Access Compliance Report

Public Rights-of-Way (Curb Ramps)

Intersection ID: 54454	Main Street: COLLINGHAM_DR	Cross Street: N/A	Location: SE
ADA ID: 32E57316EDFA	Ramp Type: Directional1	Initial Pass/Fail: Fail	Overall Compliance: No
Severity Score: 12.5			
Codes/Mitigation Info/Possible Solution		Field Measurements/Component Compliance

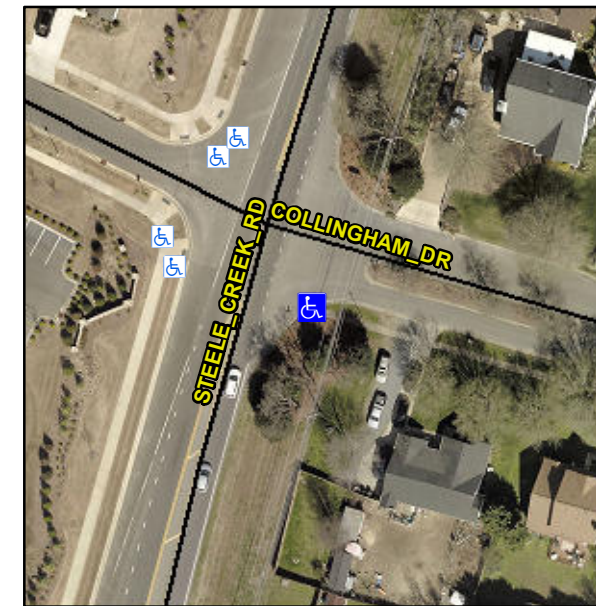
R304.2.2

Remove & Replace Entire Ramp.
